GRU Comments to the South Lagoon Phase 2 Investigation Report
Dated October 18 2017
December 28, 2017

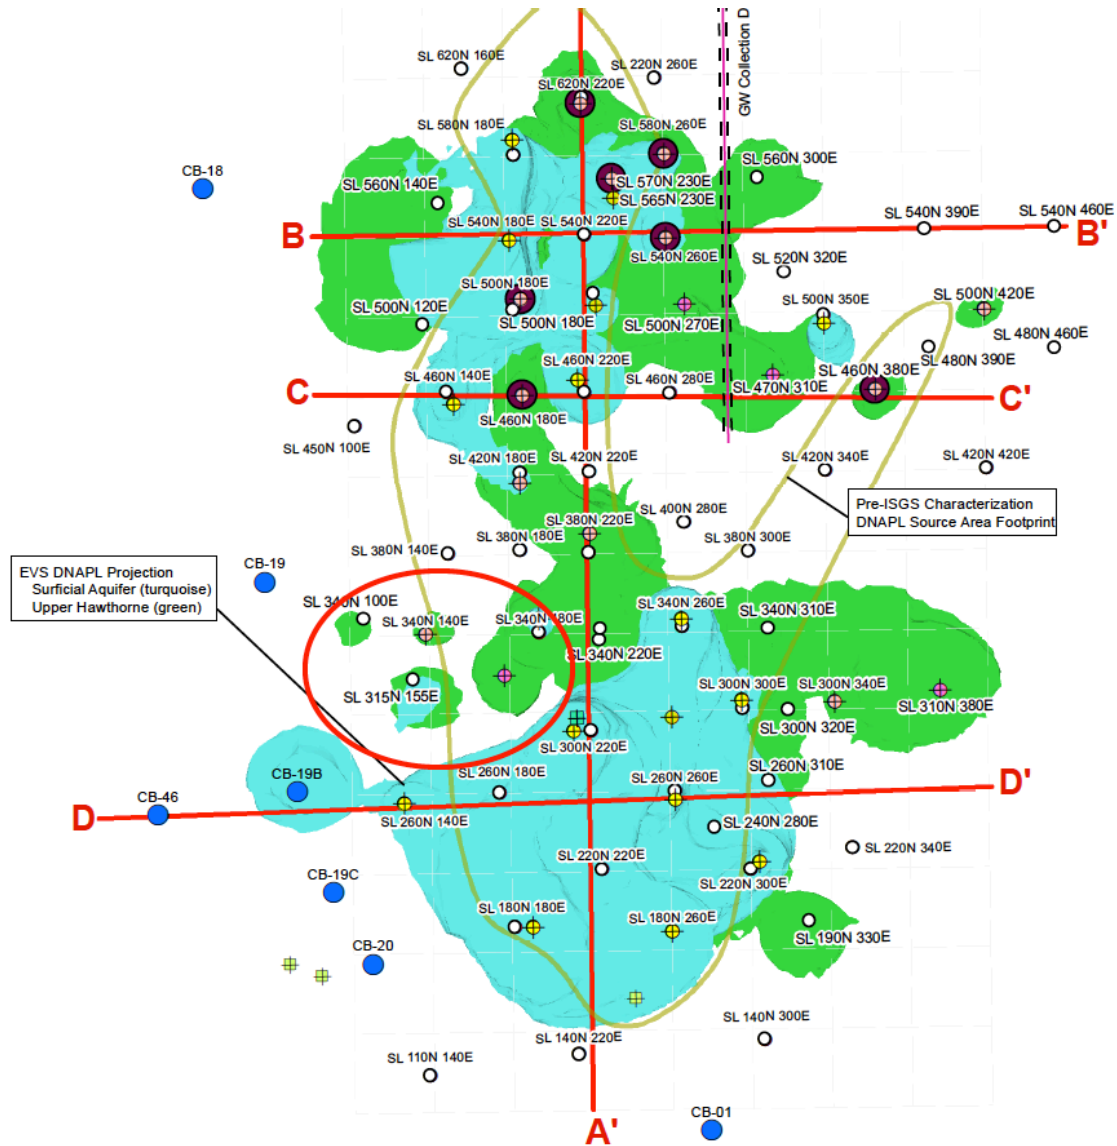
2. GRU believes it would be prudent to treat all of the area within the 240N 189E / 340N 100E area within the red circle in the attached figure. GRU believes that the three areas - interpreted by the EVS model as isolated DNAPL bodies - are actually one continuous DNAPL mass. GRU specifically proposes one or more injection points between SL-139, SL-140, and SL-155, between SL-126 and SL-127, and between SL-175 and SL-176 (See Figures 8 and 9. The injection points proposed by GRU will result in treating the entire area under discussion.

GRU believes the area within the red circle should be considered a continuous DNAPL mass for the purposes of injection.
